Bulletin No.: PI1209A

## PRELIMINARY INFORMATION

**Subject:** Poor Keyless Entry Transmitter Range

Models: 2013-2014 Buick Encore

3787937

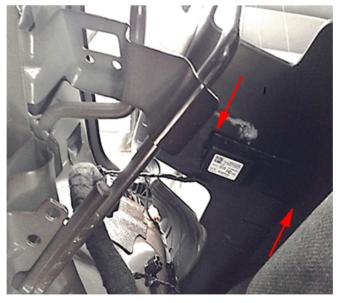
Some customers may comment on a poor keyless entry transmitter range of less than 15 m (50 ft). This may be due to the location of the remote control door lock receiver.

Relocate the remote control door lock receiver from the rear quarter panel to the adjoining trim following the procedure listed below.

- 1. Remove the LH quarter lower rear trim panel. Refer to Quarter Lower Rear Trim Panel Replacement in SI.
- 2. Release the receiver from tabs on bracket.
- 3. Using hook and loop velcro such as Kent Industries Part# KT14369 or equivalent, cut a piece the length of the receiver and apply on the bottom side.

4. Remove the velcro and install the receiver in its new location as shown in the illustration above.
